**Technical Report by Greg Karras**

16 December 2021

**Phillips 66 Company Rodeo Renewed Project****Draft Environmental Impact Report,**

County File No. CDLP20-0240,

## 1. HEFA feed fatty acid profiles by number of carbon double bonds.

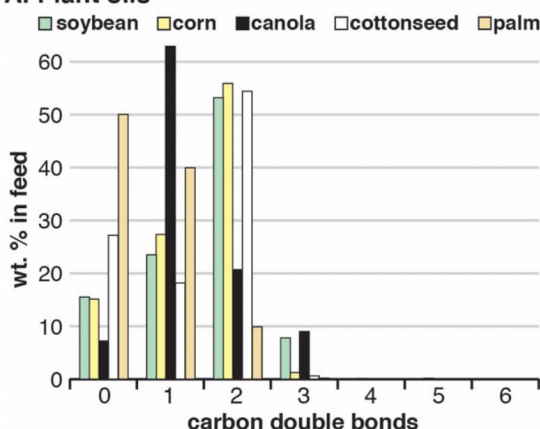
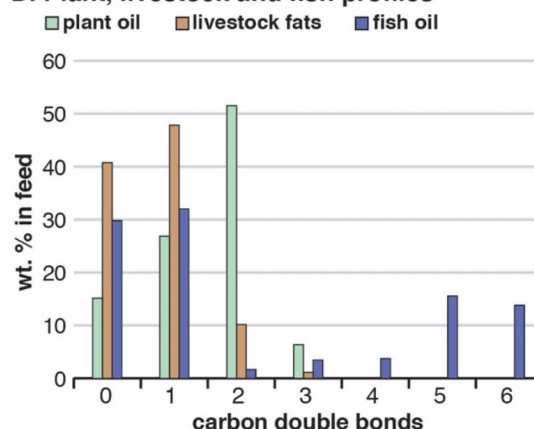
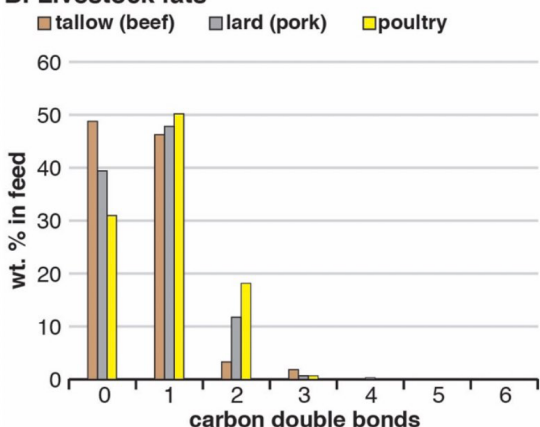
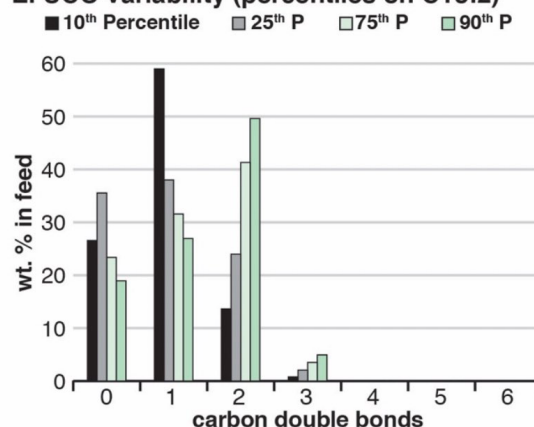
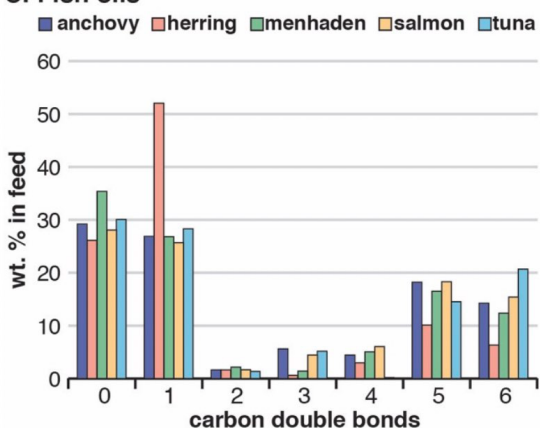
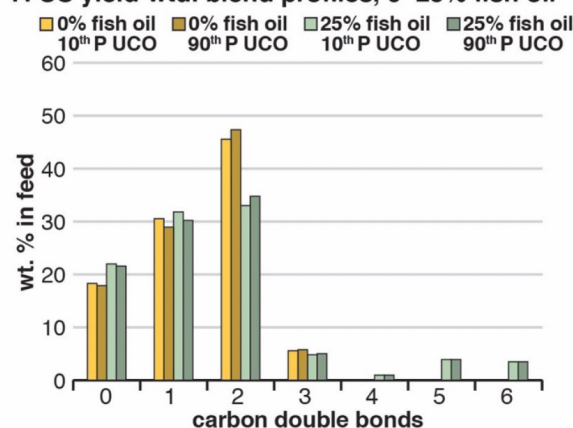
Differences in project processing impacts caused by differences in refinery feedstock, as discussed above, are caused by differences in the chemistries and processing characteristics among feeds that the DEIR does not disclose or describe. For example, feed-driven differences in process hydrogen demand discussed above both boost the carbon intensity of HEFA refining above that of petroleum crude refining, and boost it further still for processing one HEFA feed instead of another. The first impact is driven mainly by the uniformly high oxygen content of HEFA feedstocks, while the second—also environmentally significant, as shown—is largely driven by differences in the number of carbon double bonds among HEFA feeds.<sup>42</sup> This difference in chemistries among HEFA feeds which underlies that significant difference in their processing characteristics can be quantified based on available information. Charts 1.A–1.F, excerpted from Attachment 2, show the carbon double bond distributions across HEFA feeds.

The DEIR could have reported and described this information that allows for process impacts of potential project feedstock choices to be evaluated, but unfortunately, it did not.

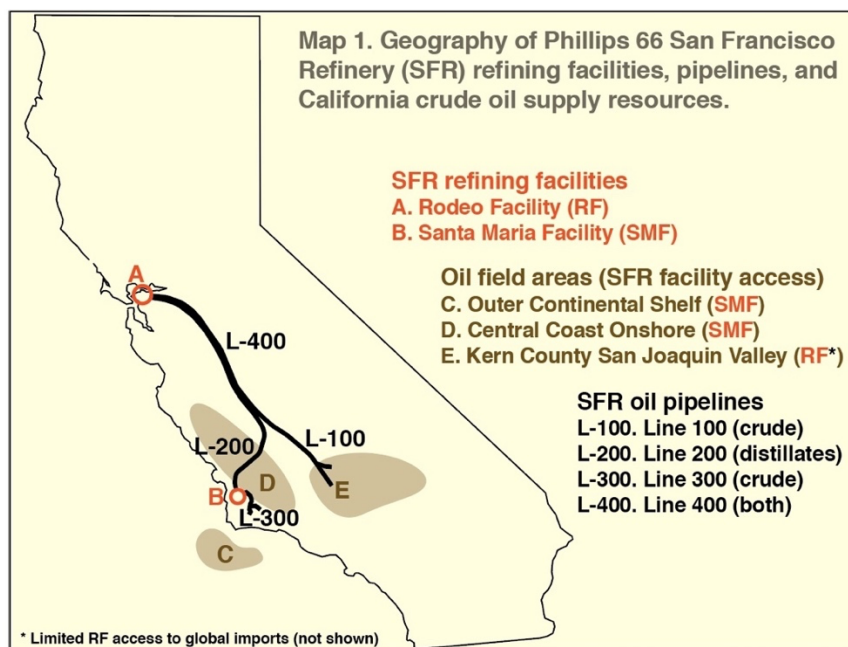
The DEIR does not disclose, evaluate, or accurately describe the functional interdependence of SFC components, their unique geography, and the resultant unique limitations in accessible crude feedstock for the SFC. Map 1 illustrates the unique geographic distribution of SFC components in relation to the landlocked crude resources that the SFC was uniquely designed to access for feedstock.<sup>158</sup> The Rodeo Refining Facility (RF) of the SFC (“A” in Map 1) receives most of its oil feed as crude from San Joaquin Valley oilfields (“E”) that is blended with, and crucially, thinned by, oils processed in its Santa Maria Refining Facility (SMF) (“B”) from crude that its pipeline system collects from offshore (“C”) and onshore (“D”) Central Coast oilfields.

These existing conditions in the project setting that the DEIR omits or describes inaccurately have a profound systemic effect on the project baseline. Instead of pipeline access to the largest regional crude resource in California<sup>166</sup> as the DEIR wrongly describes, the SMF lacks both that access, and seaport access to imports that provide the largest source of crude refined statewide,<sup>167</sup> which the DEIR also fails to disclose. That doubly limited access makes SMF operations exceptionally vulnerable to loss of local crude supply. The systemic effect has to do with how changes in the mix of San Joaquin Valley crude and semi-refined oils from the SMF flowing to the RF—that mix in the pipe to the RF being a fact the error in the DEIR described above also obscures—could limit crude supply for the RF.
